NLT8FX, NLT8FX-BAG

Engineering Change Notice

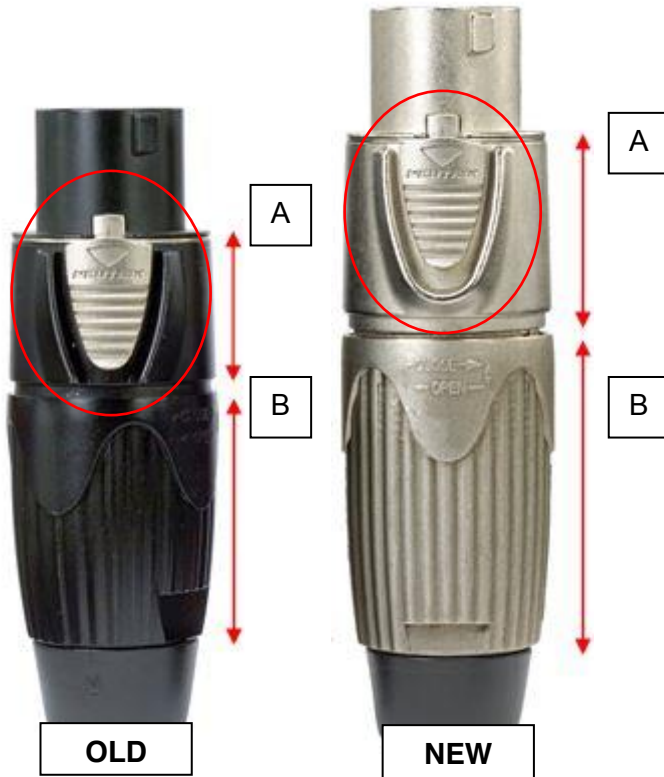
In order to give the customer more room to terminate the connector we have increased the length of the housing by 16mm. To protect the latch even better the ridge around the latch got improved (NLT8FX & NLT8FX-BAG).

OLD: A→24.50mm
B→40.90mm

NEW: A→29.50mm
B→51.90mm

The total length is increased by 16mm longer.
